ADDENDUM

Project Name:	UNK University Village Student Housing
Project Number:	15097
Owner:	University of Nebraska at Kearney
Addendum Number:	01, Revision 01
Date:	April 21, 2016
By:	Matt Neaderhiser, Holland Basham Architects
To:	Project Bidders

This Addendum to the project bidding documents and attached reference drawings dated April 21, 2016, issued to inform bidders of revisions to the bidding documents.

1 E1.03A THIRD FLOOR LIGHTING PLAN - WEST WING

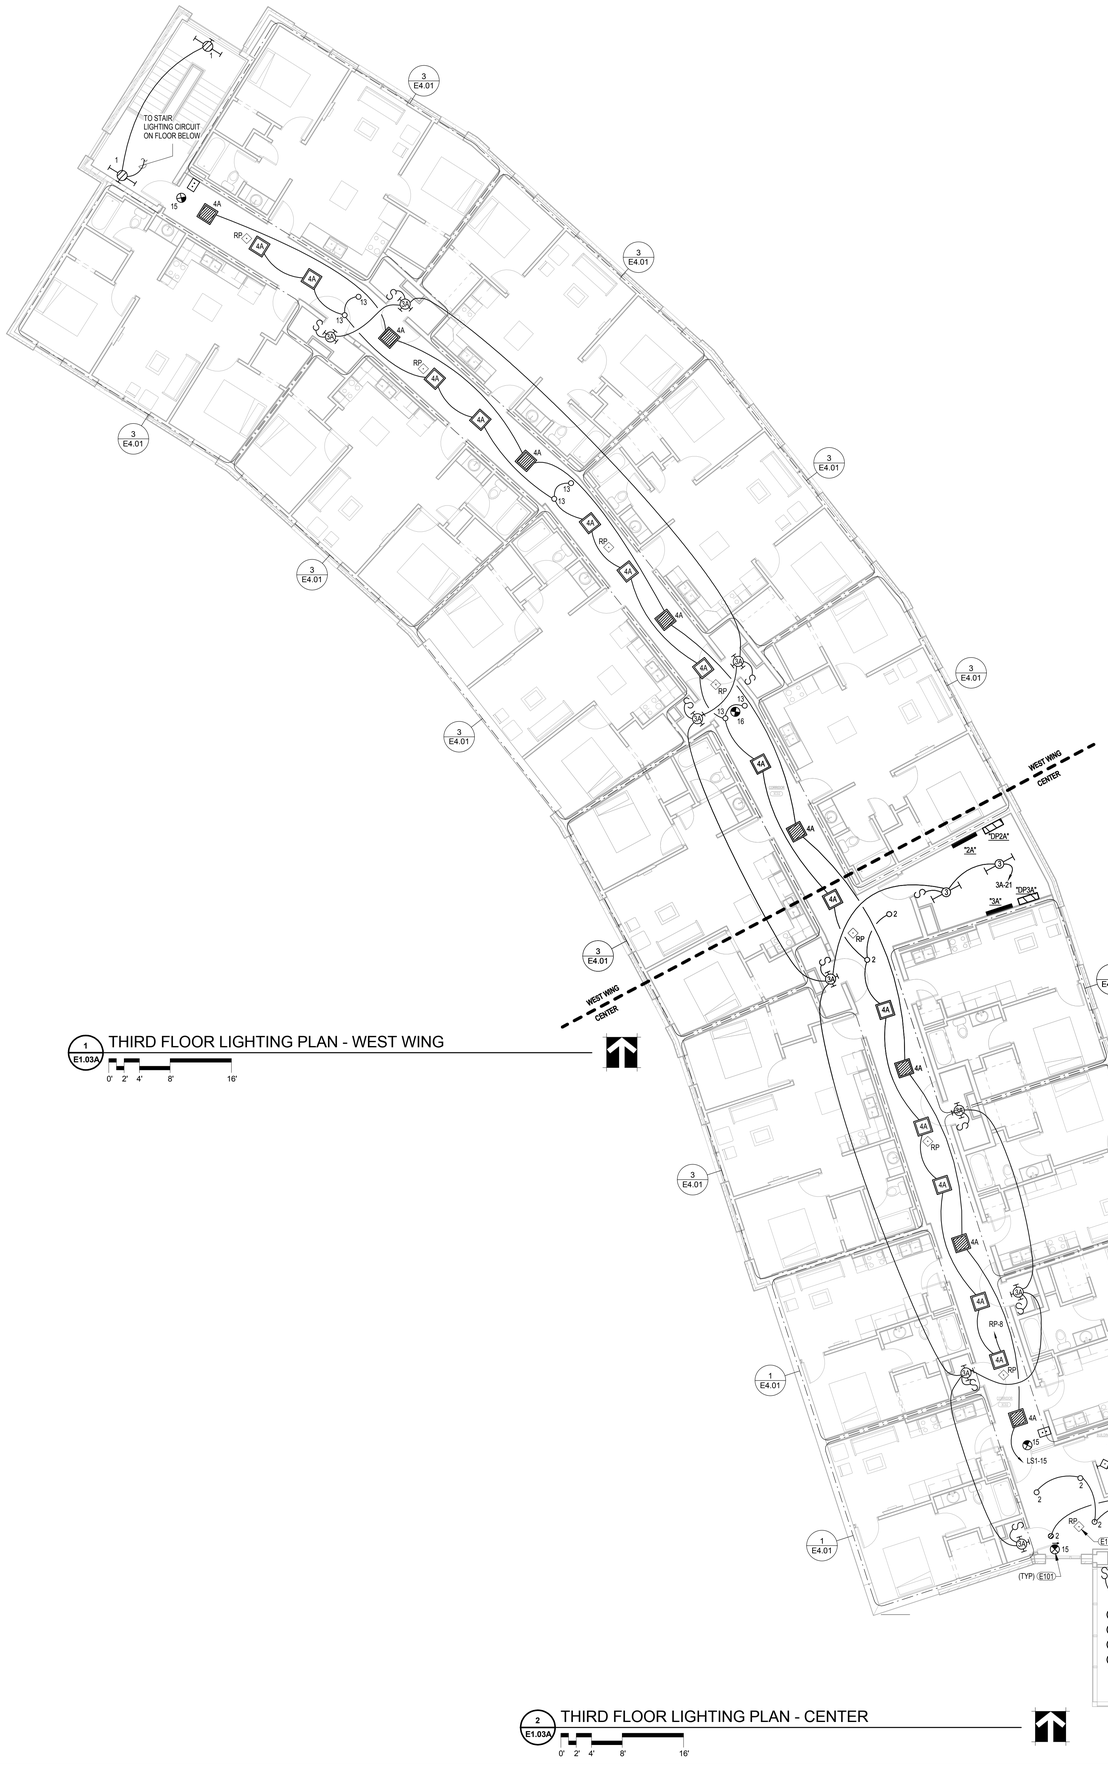
5. Sheet E1.03A – Third Floor Lighting Plan – West Wing & Center
    a. Add automatic load control relays.

1 FIRST FLOOR POWER PLAN - WEST WING
E2.01A
0' 2' 4' 8' 16'

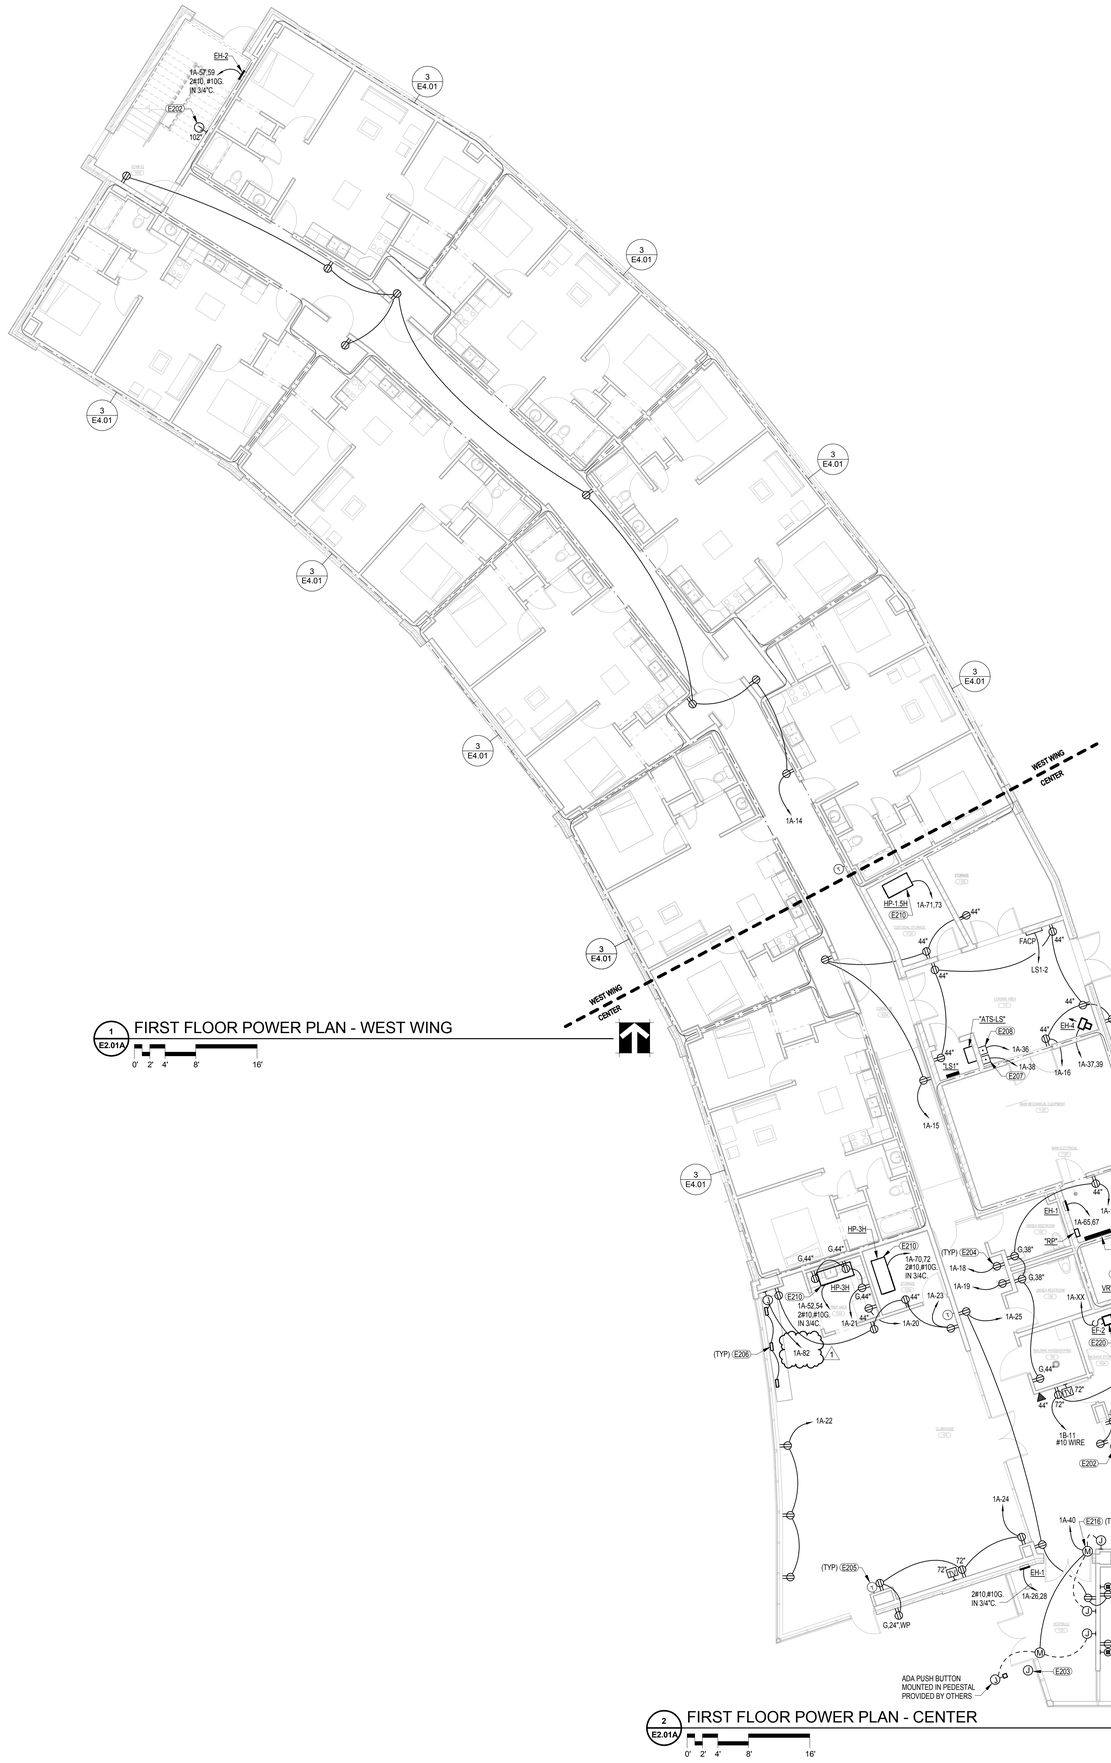
6. Sheet E2.01A – First Floor Power Plan – West Wing & Center
    a. Clarify circuit numbers.

1 E2.02B SECOND FLOOR POWER PLAN - EAST WING

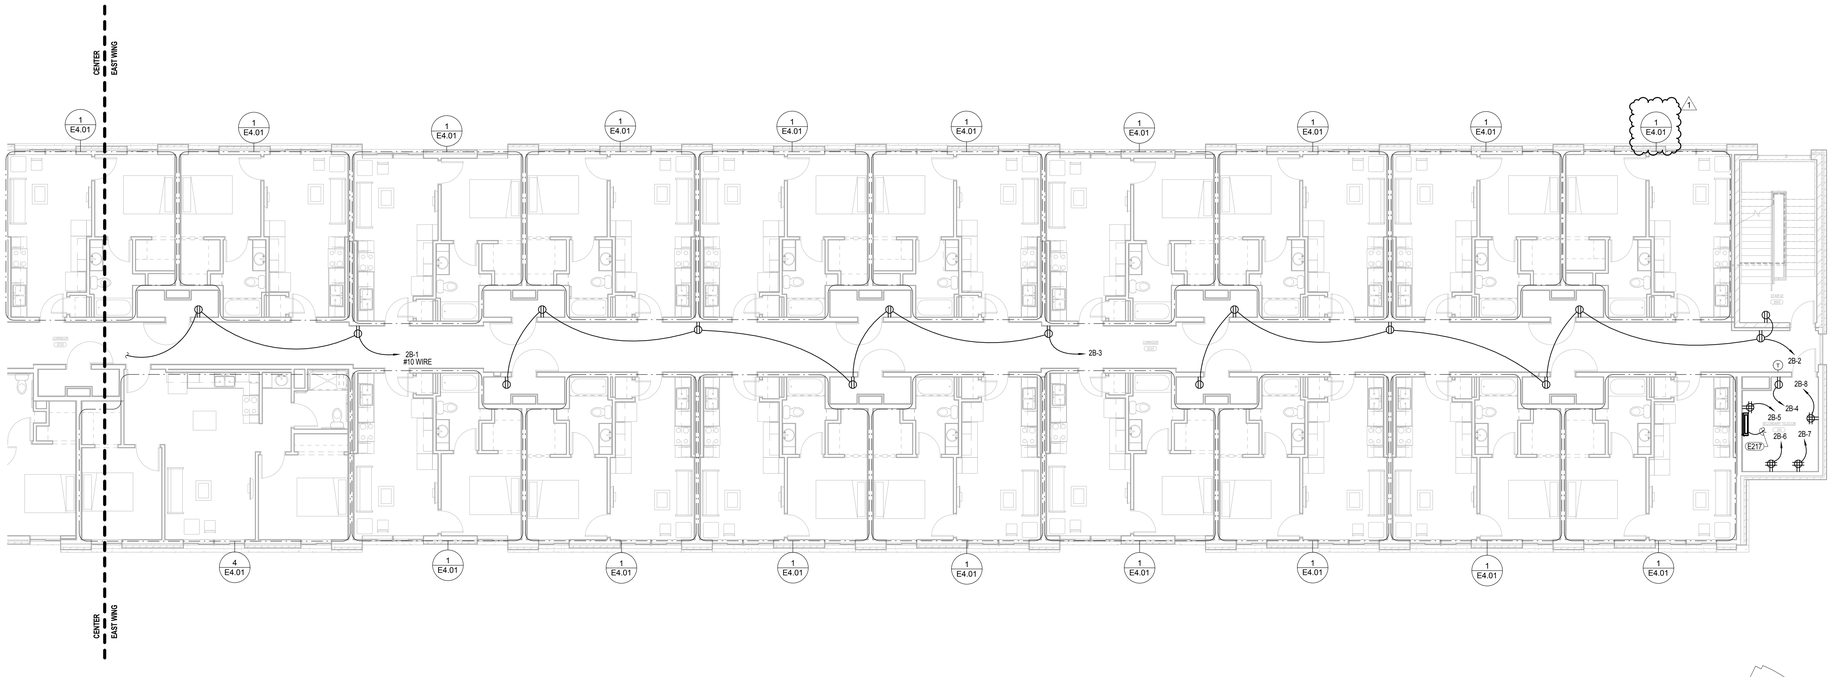
8. Sheet E2.02B – Second Floor Power Plan – East Wing
    a. Clarify detail reference number.

1 E2.04A ROOF POWER PLAN - WEST WING

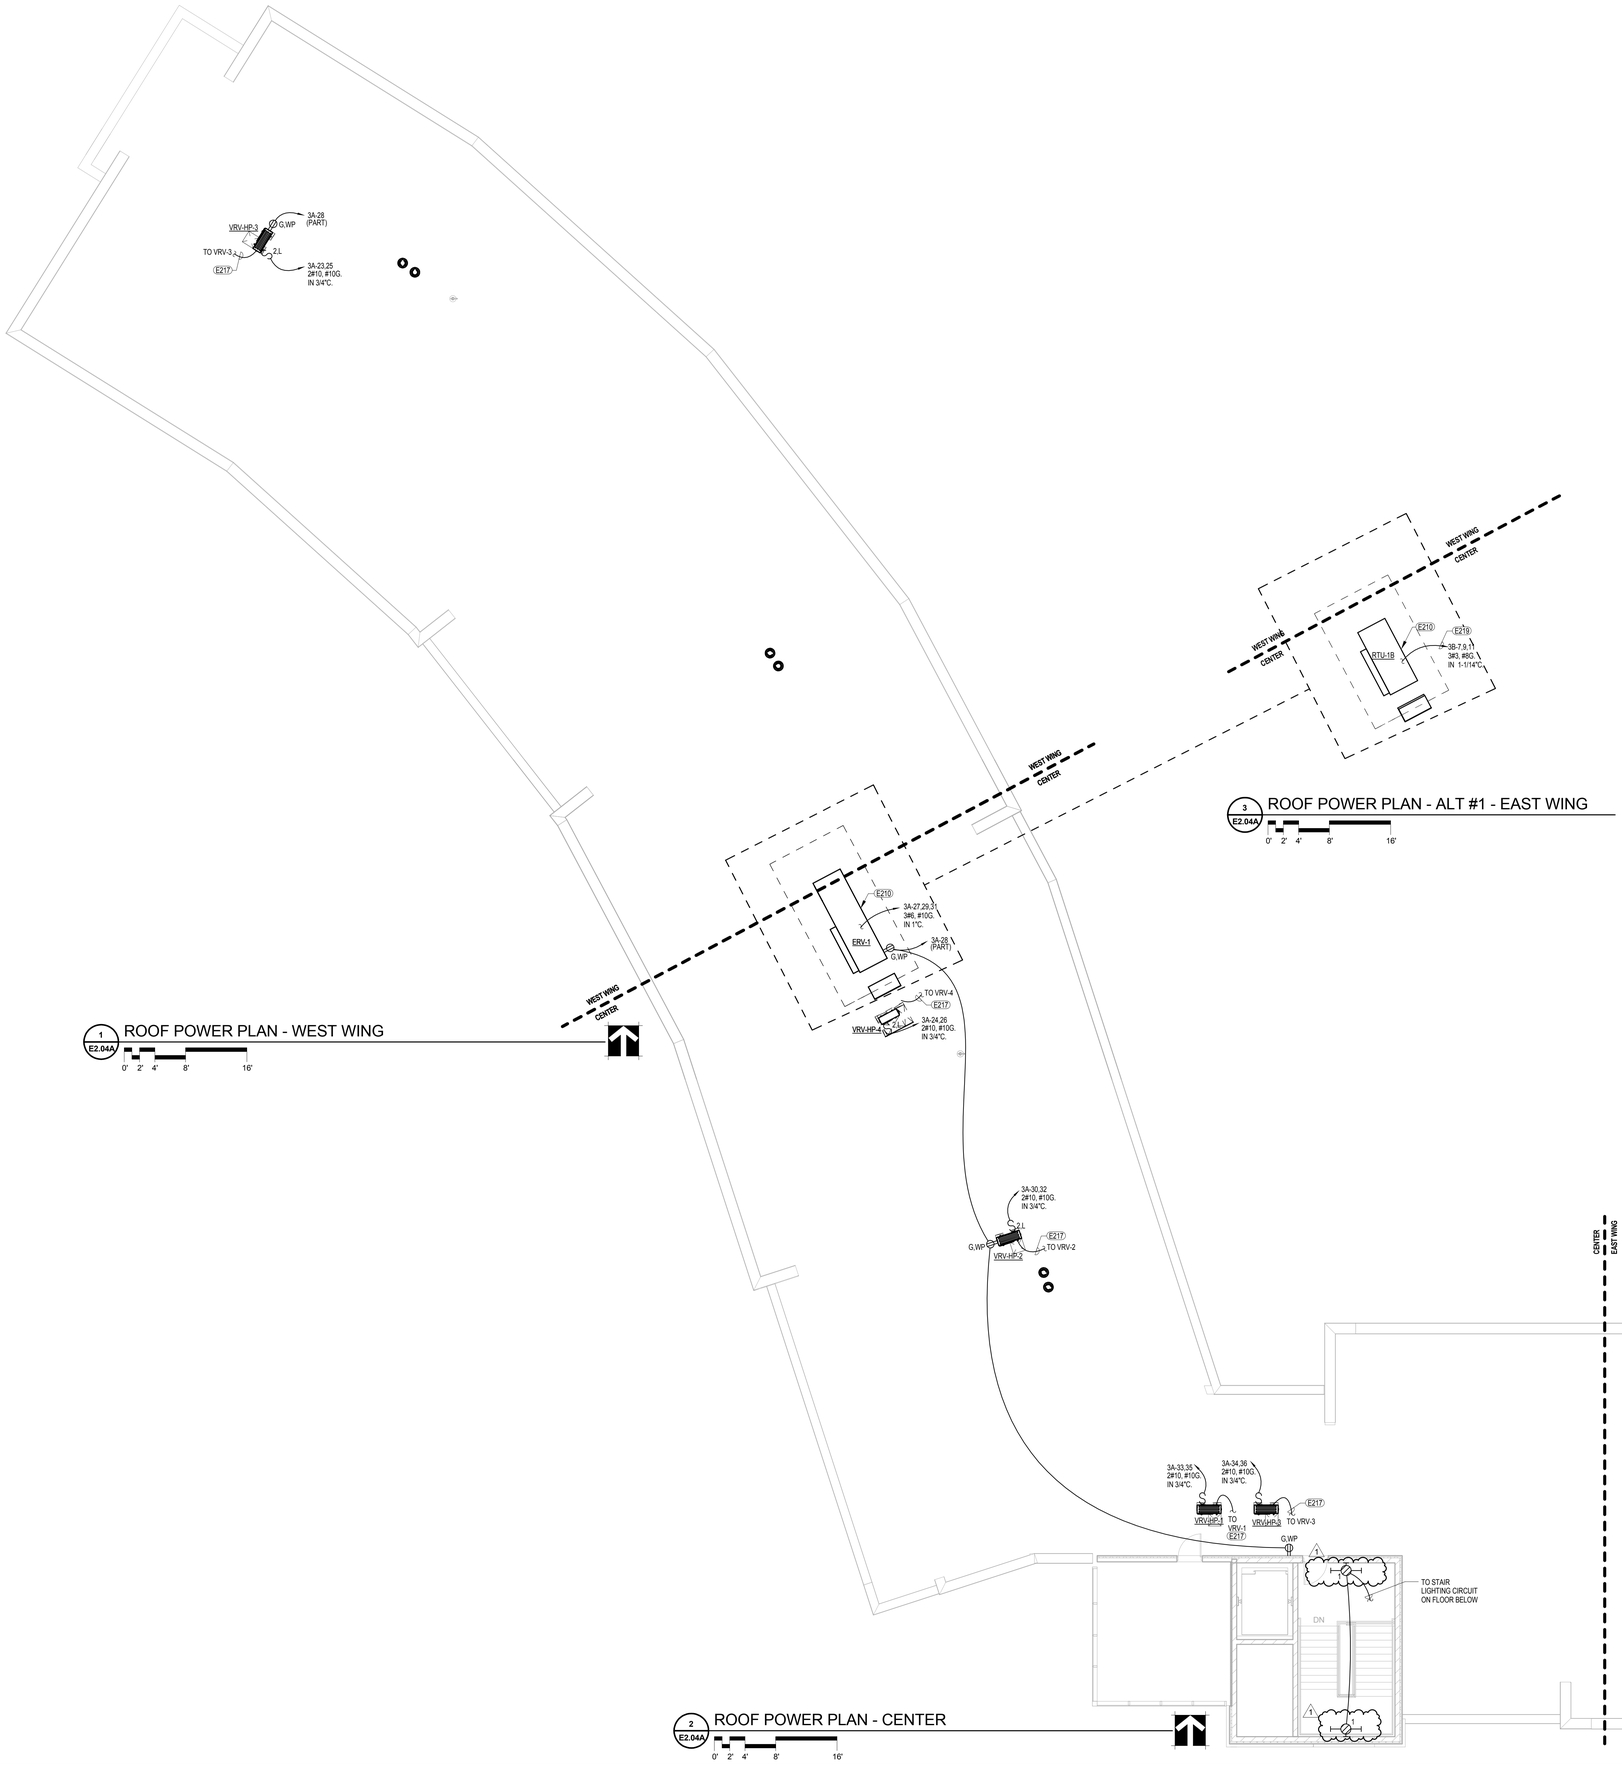
9. Sheet E2.04A – Roof Power Plan – West Wing & Center
    a. Clarify lighting fixture type in stairs.

1 E3.01B FIRST FLOOR SPECIAL SYSTEMS - EAST WING

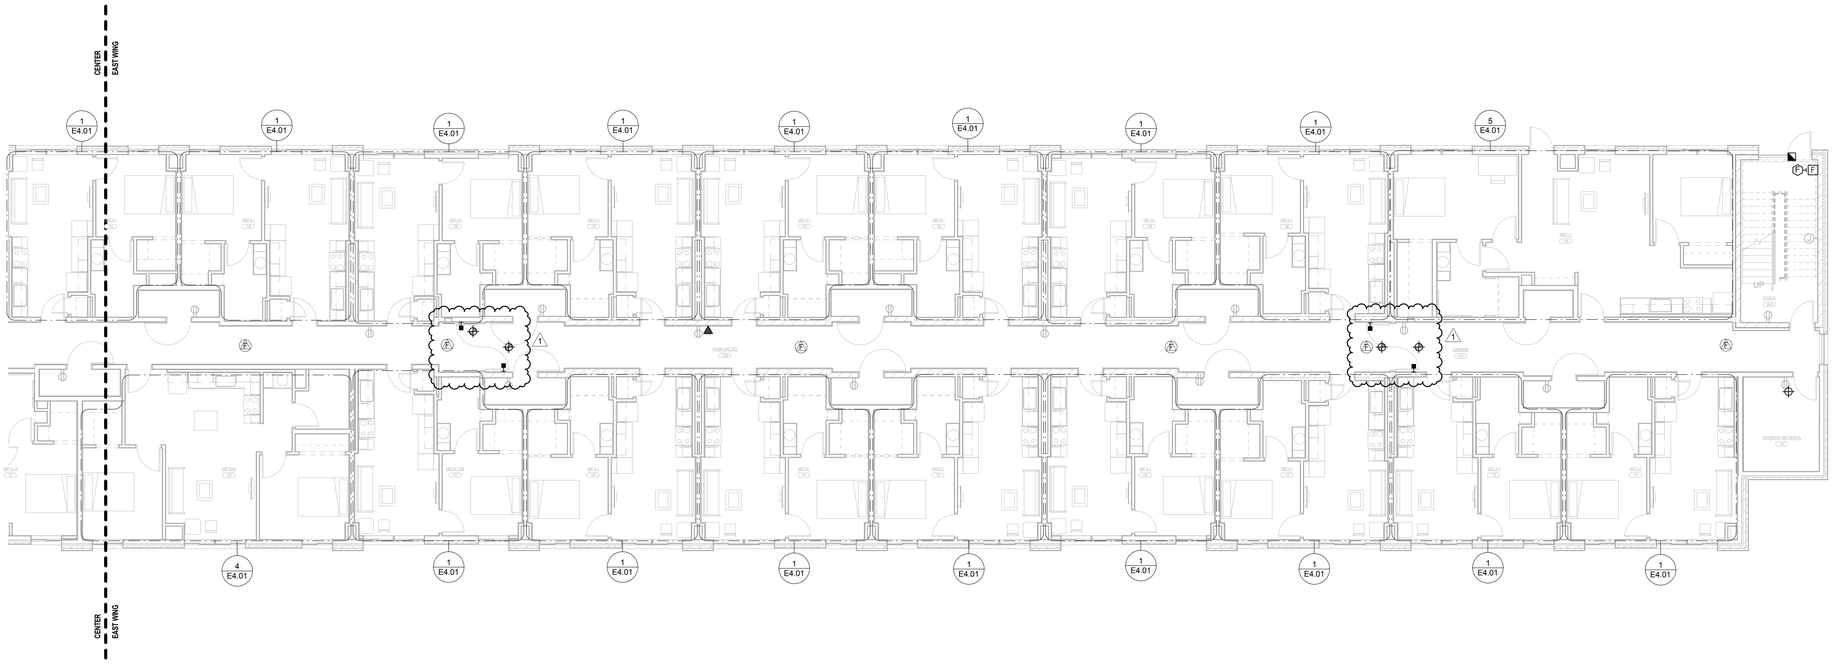
7. Sheet E3.01B – First Floor Special Systems Plan – East Wing
    a. Add fire alarm door hold opens and associated smoke detection.
